<b>CITY OF WESTMINSTER</b>			
<b>PLANNING APPLICATIONS COMMITTEE</b>	<b>Date</b> 29 November 2016	<b>Classification</b> For General Release	
<b>Report of</b> Director of Planning		<b>Ward(s) involved</b> Hyde Park	
<b>Subject of Report</b>	<b>31 Hyde Park Gardens Mews, London, W2 2NX,</b>		
<b>Proposal</b>	Demolition of the existing two storey building and erection of a new three storey building and excavation of basement to create two residential dwellings.		
<b>Agent</b>	Mr R W Stevens		
<b>On behalf of</b>	Camal Architects		
<b>Registered Number</b>	16/06420/FULL	<b>Date amended/ completed</b>	25 July 2016
<b>Date Application Received</b>	7 July 2016		
<b>Historic Building Grade</b>	Unlisted		
<b>Conservation Area</b>	Bayswater

**Reference:** 16/06420/FULL

Proposed floor plans:

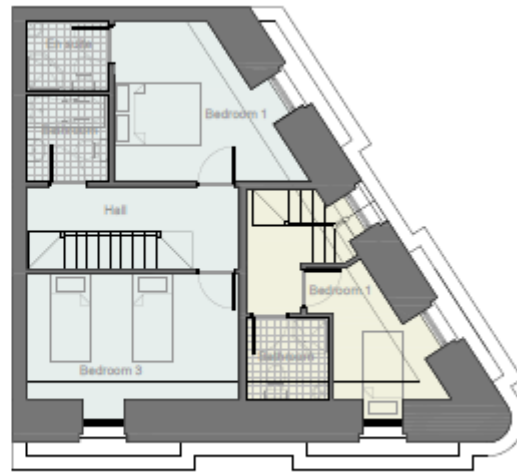
In terms of the size (floorspace) of the proposed residential units, 'bedroom 1' of the smaller dwellinghouse on the east side of the development would fall marginally below the minimum size for bedrooms as set out in the Nationally Described Space Standards, as it has a floor area of 5.2m<sup>2</sup> which is below the floor area specified in the space standards for single bedrooms of 7.5m<sup>2</sup>. However, as the overall size of the two bedroom dwellinghouse would be 86m<sup>2</sup>, which is above the minimum requirement for a two bedroom house in the Nationally Described Space Standards, and as 'bedroom 1' could

However, whilst the overall size of the two proposed dwellinghouses is acceptable, the standard of residential accommodation they would provide for future occupiers is not acceptable. This is because the layouts proposed would provide the kitchens and dining rooms at basement level where they would receive very little natural light from the very narrow lightwells to the two street facades of the building. These habitable rooms are likely to be heavily used by future occupiers and their location at basement level in what will be a poorly lit part of the proposed development is inappropriate and would be contrary to Policy ENV13 in the UDP, Policy S29 in the City Plan, Policy 3.5 in the London Plan (2015 – as amended) and the guidance in the Mayor's 'Housing' SPD (2016).

- Amended detailed design and form that is more in keeping with the character and appearance of the mews.
- Amended internal layout of residential accommodation and relocation of lightwells away from the street facades of the site.

PROPOSED

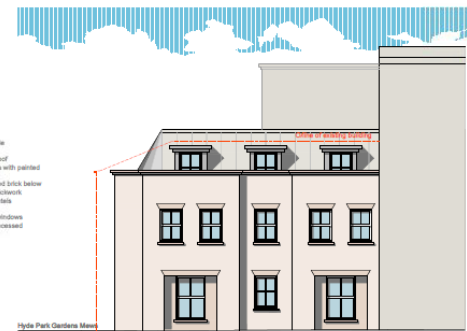
The mansard roof storey is proposed to be clad in lead, which is not considered to be an appropriate facing material in this prominent location given that slate is the almost universal cladding material used on mansard extensions in the vicinity. In addition, on the Hyde Park Gardens Mews elevation, the mansard stops short of the western party wall which would create a wholly inappropriate gap to the skyline of the terrace.

The basic impression of the proposed building would be as a distinct pair of small townhouses. This approach contrasts markedly with the character of the street where the very distinct and different mews style of building design predominates. The building proposed is considered to be out of character with its surroundings and would be detrimental to the prevailing appearance of the mews.

The detailed design proposed comprises a series of vertically proportioned bays, which step in and out across both street elevations, with an inset curved corner to the junction of Sussex Place and Hyde Park Gardens Mews. The bays and curved corner are not found to buildings in the mews, and are wholly inappropriate design detailing within this traditional mews setting where detailed design should conform to the guidance provided in the Supplementary Planning Guidance document 'Mews – A Guide to Alterations' (1992). The street is characterised by a consistency of building line and buildings do not have the 'rhythm' of the elevations proposed in this case.

The paired entrance doors proposed are also not found elsewhere in the mews and, paired with the large projecting canopy structure above, they are an excessively grand statement where surrounding mews buildings are wholeheartedly restrained in their design approach.

The proposed ground floor windows would be recessed behind the main elevation lines and these wide recessed openings, with window arches above are not considered appropriate detailing. Their inclusion appears to a contrived device to accommodate very shallow lightwells to basement level between the front elevation of the proposed building and the public highway. The provision of visible lightwells to the street elevations is unacceptable in principle in design terms and would undermine the restrained proportions and scale of mews houses, which are typically limited to two or three above ground floors. A further concern is that the cover over the lightwells is not specified in the application. Returning to the ground level façade, the windows also appear from the annotations on the submitted drawings to be further elaborated by having a differing colour to the brickwork facing to the building and this too is of concern in design terms.

The bay features proposed would give a vertical emphasis, which would be in contrast to the horizontal emphasis of other mews buildings on the street, which have garages and an implied or overtly defined termination to the ground floor in the form of an exposed beam. The lack of a garage to ground floor level further divorces the building from its mews context. At first floor level the surrounding mews buildings almost uniformly have a

The proposed inset curved corner at the junction of Hyde Park Gardens Mews and Sussex Place would enlarge and exaggerate the entrance to the main section of the mews by providing a 'feature' which is entirely inappropriate for a mews setting that is characterised by a restraint in the general design approach. The mews is specifically intended as a contrast to the much more elaborately designed terrace properties to the surrounding principal streets and the existing narrower entrance to the mews more appropriately provides this distinction.
